Construction Change Directive

PROJECT: <i>(Name and address)</i> John Knox Village - Meadows 400 NW Murray Road Lee's Summit, MO 64081	DIRECTIVE NUMBER: 050 DATE: June 26, 2017 CONTRACT FOR: General Construction	OWNER: ☒ ARCHITECT: ☒ CONSULTANT: ☐ CONTRACTOR: ☒ FIELD: ☐ OTHER: ☐
TO CONTRACTOR: <i>(Name and address)</i> Paric 77 Westport Plaza Suite 250 St. Louis, MO 63146	CONTRACT DATED: June 23, 2015 ARCHITECT'S PROJECT NUMBER: 13129.00

Please make the following revisions to the Commons building at the Meadows project.

**FIRST FLOOR COMMONS
WATER & GAS PIPING**

P2.1
20 OF 39

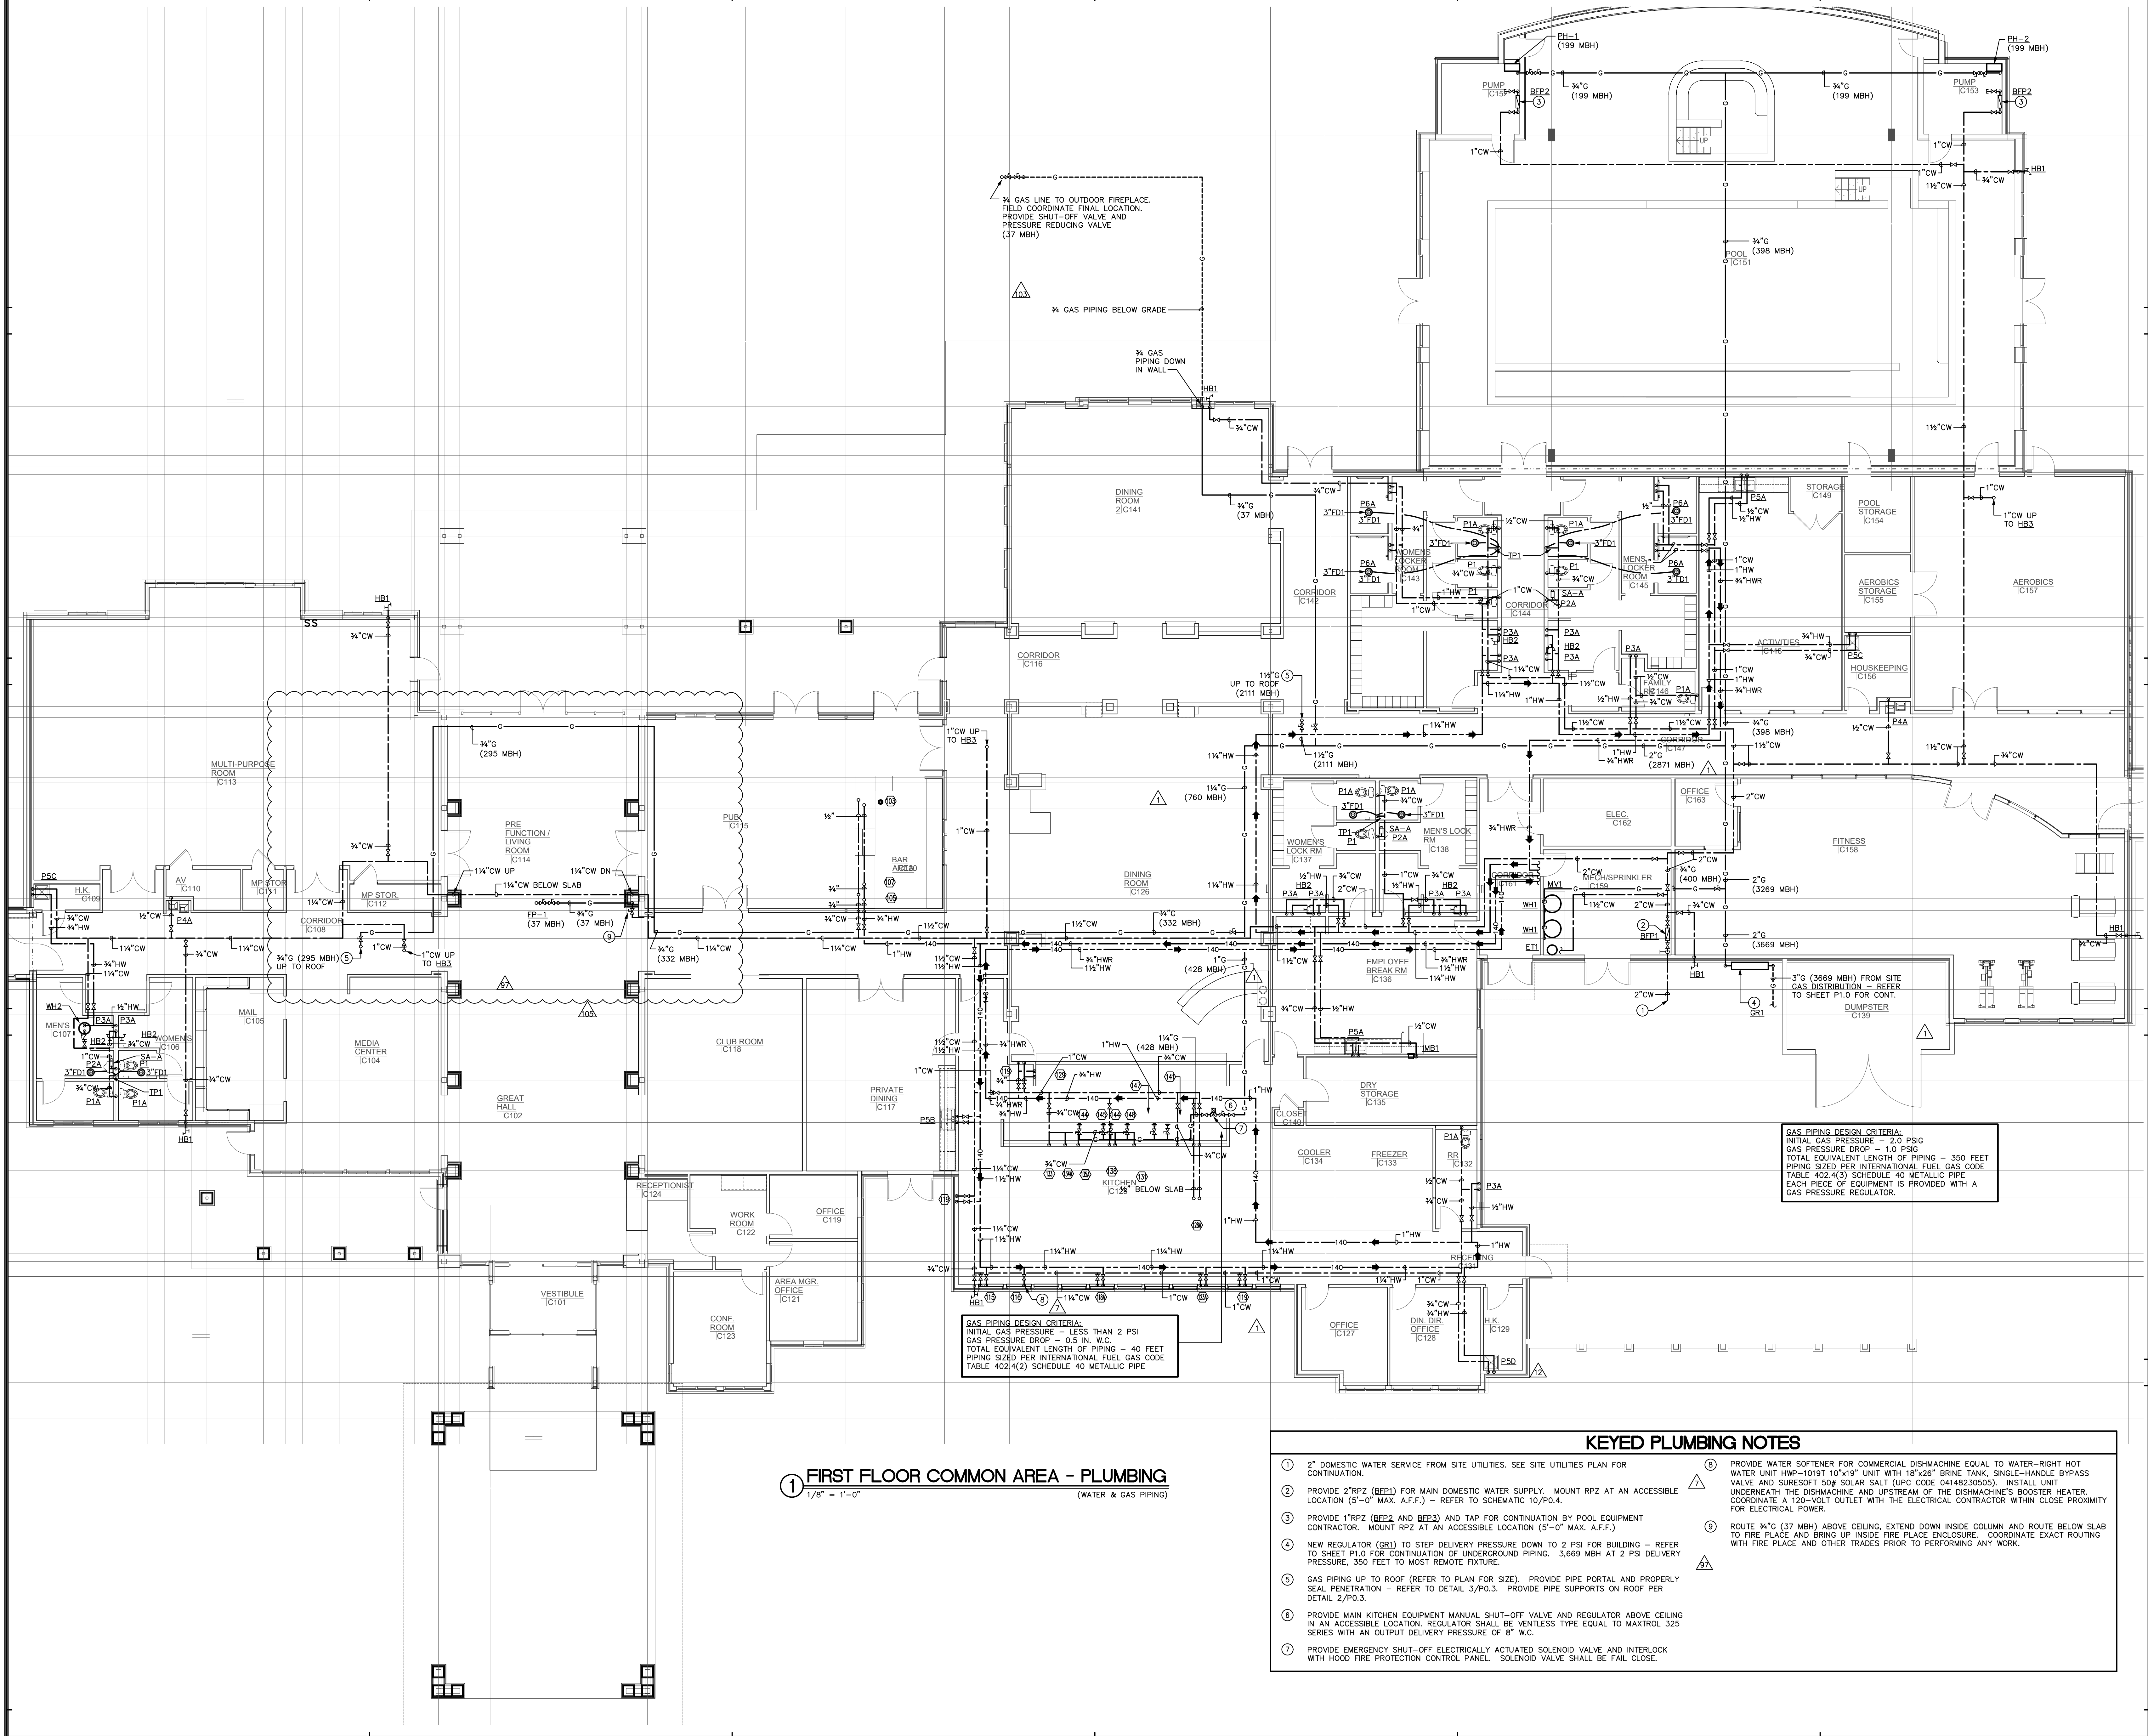
- ROUTE 3/4" (37 MBH) ABOVE CEILING, EXTEND DOWN INSIDE COLUMN AND ROUTE BELOW SLAB TO FIRE PLACE AND BRING UP INSIDE FIRE PLACE ENCLOSURE. COORDINATE EXACT ROUTING WITH FIRE PLACE AND OTHER TRADES PRIOR TO PERFORMING ANY WORK.
